Reference: Shallow Monitoring Wells – Proposed Change to Work Plan  
Chemical Recovery Systems, Inc. (CRS) Site  
Elyria, Lorain County, Ohio

For the reasons stated below, the CRS Site Group requests a change to the approved RI/FS Work Plan to forego installing shallow groundwater monitoring wells planned for areas where shallow groundwater has not been detected.

**Figure 3-1**  
**Conceptual Site Model**  
**CRS Site**  
**Elyria, OH**

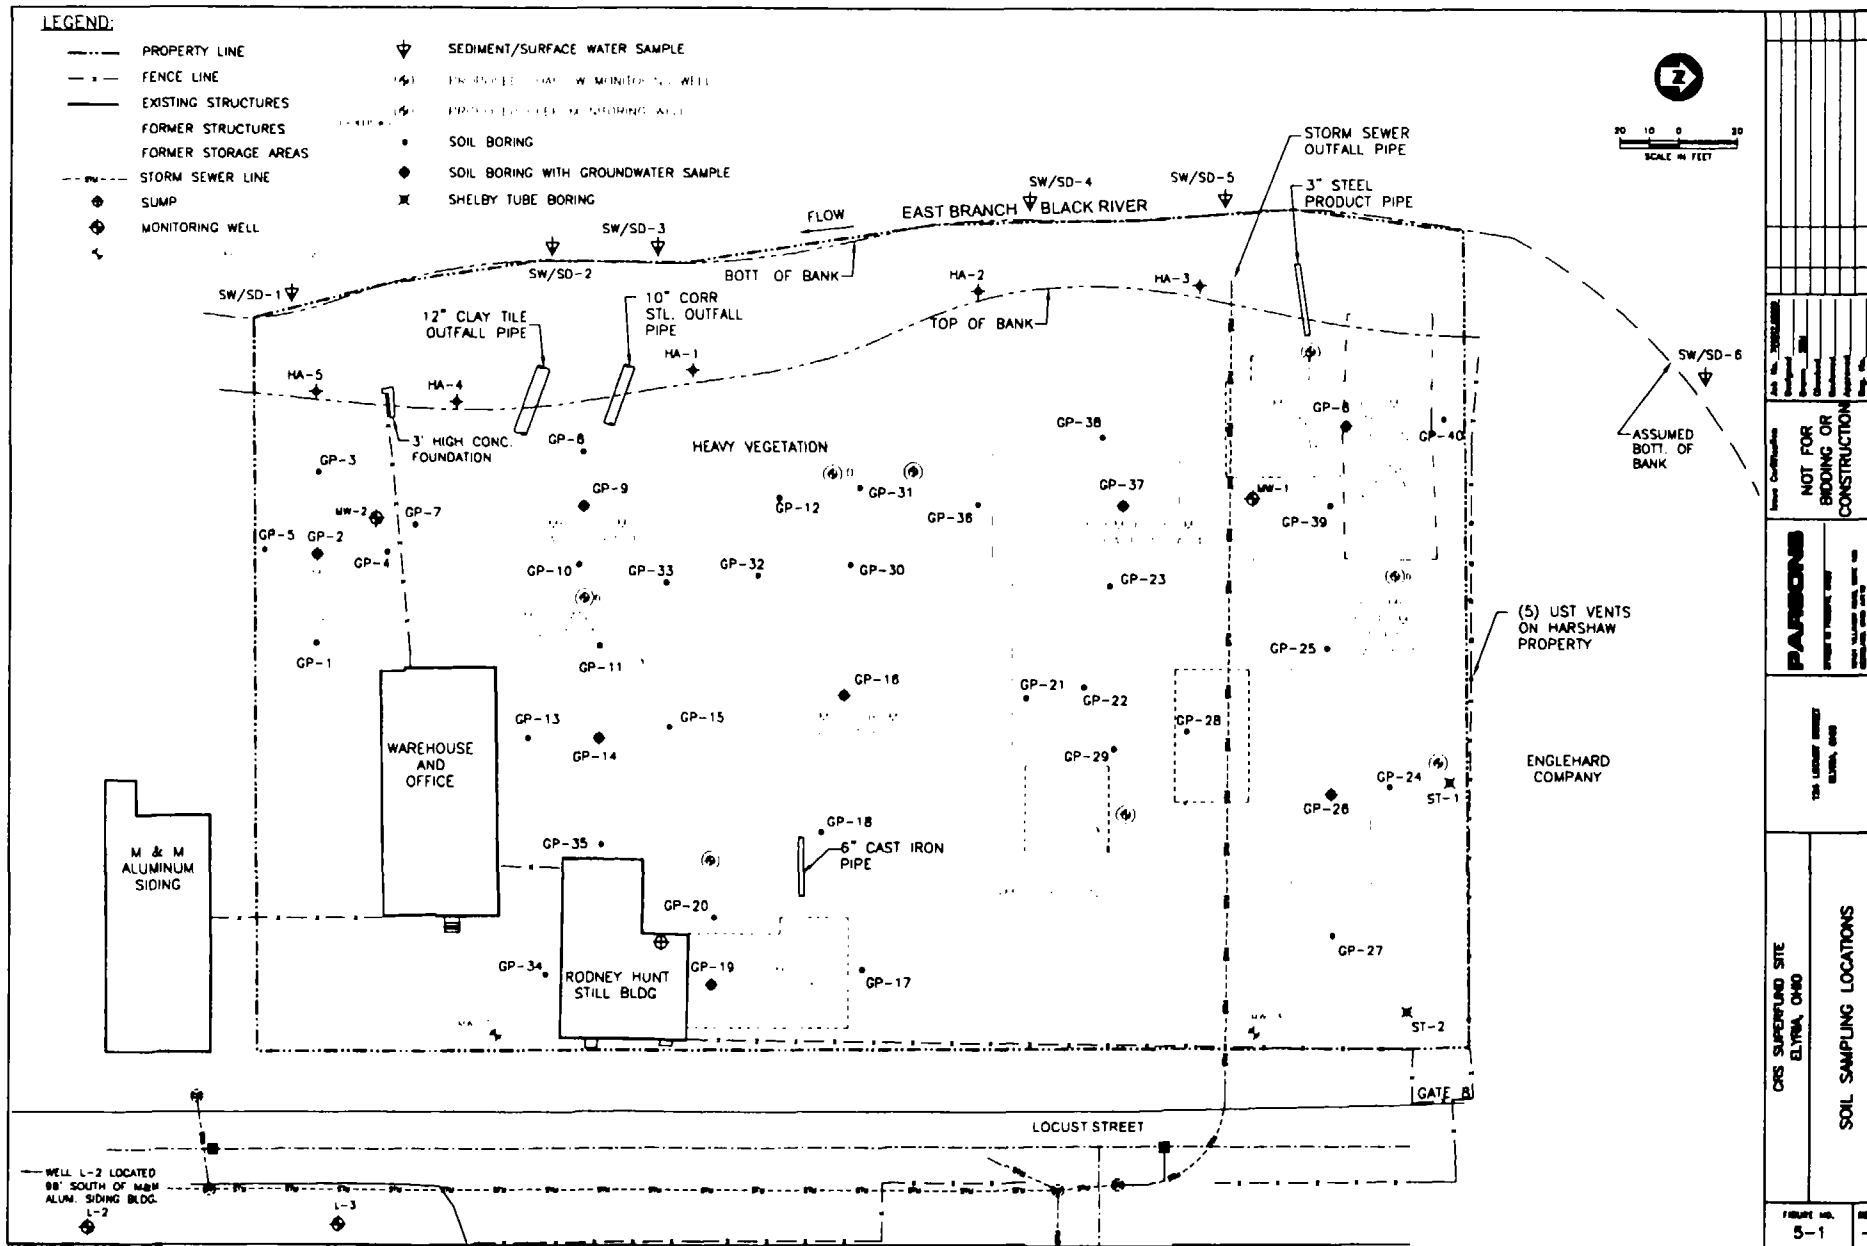
The conceptual site model (CSM) (Figure 3-1 – attached) associated within the United States Environmental Protection Agency (U.S. EPA) approved Remedial Investigation/Feasibility Study (RI/FS) Work Plan was based, in part, on the premise that there were multiple distinct and definable historic sources or areas of concern (AOC) (Rodney Hunt still building, Brighten still building and above ground storage tank (AST) farm, drum storage areas, tanker storage areas and storm sewer outfall) on the referenced property. As such, the initial phase of field work included advancing 40 direct-push soil borings (five in each AOC – in the center and to the north, south, east and west) and collecting soil samples for field and laboratory analysis for the purpose of defining the extent of each historic source area. In addition, the CSM was based, in part, on the premise that there was abundant shallow groundwater in the unconsolidated material (mostly fill), which overlies sandstone bedrock. Following this line of reason, the initial phase of field work also included the installation of eight temporary groundwater monitoring points.

A review of the analytical results from soil samples collected from the borings indicates that the majority of the samples were impacted with chemicals of concern (COCs). Although the type and concentrations of COCs (e.g., volatile organic compounds (VOCs) or semi-volatile organic compounds (SVOCs)) may differ from one location to another at the site, there are no distinct, definable AOCs (sources) at the site as originally assumed in the CSM. Therefore, the entire site is considered to be one source area (AOC).

Based on the lithologic and analytical data now available from the first phase of RI activities, the CSM and the assumptions used to determine the need for the installation of permanent monitoring wells in the unconsolidated material, has been reviewed and adjusted. Installing shallow wells at the site to determine if specific AOCs are contributing COCs to the groundwater is no longer necessary. This rationale is based on the following:

The CRS Site Group proposes installing the three deep monitoring wells as outlined in the RI/FS Work Plan. However, the CRS Site Group requests that you approve a change in the Work Plan that eliminates the installation of the five proposed shallow wells because groundwater is not present in these areas based on the above information. Further, sufficient data for developing the risk assessment for the site are available from other sources and locations.
